SUBJECT: Additional Comments on Staff Report / APC Referral Report

REFERRAL REPORT

SUBJECT: Application No. RZ23A03 (Stone Bridge)

Figure 1 - *Show Home Concept*

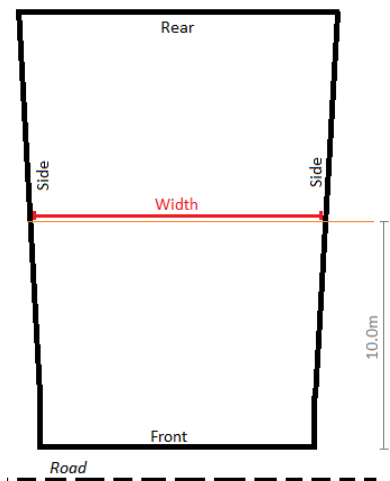
- F. The ability to construct up to six show homes on one parcel will allow show homes to be constructed prior to the subdivision of the land, therefore helping to expedite bringing housing to the market. This small change to allow multiple homes on one parcel also expands the housing options available to include cluster housing. Cluster housing is great for using oddly shaped parcels and is often focused on affordable family or seniors housing.
- G. Following the APC meeting where there was support for a short term / hotel type housing option in the area, we have been doing research into “extended stay” hotel formats and have found that most major hotel brands offer this hotel option.

F The applicant is requesting a zoning provision that would enable multiple homes to be built on a single lot that is capable of further subdivision. A zoning regulation reduces the risk/liability to the CVRD in the event that show homes are sold and/or occupied prior to subdivision by enabling the development of a multiple dwelling building strata.
